ADA Curb Ramp New Construction Inspection Form (Parallel)

NW Timeric

23885.56

NW Lenox

PARALLEL RAMP (PL)

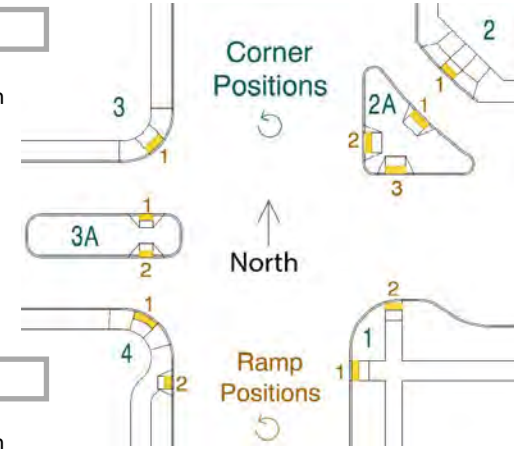
Y ☐ N ☒

$\leq 1/4"$ ☐ $> 1/4"$ ☒

4.1 $\leq 2.0\%$ ☐ $> 2.0\%$ ☒

10 $\leq 2.0\%$ ☐ $> 2.0\%$ ☒

NO DWS Fail RR and Turn Space
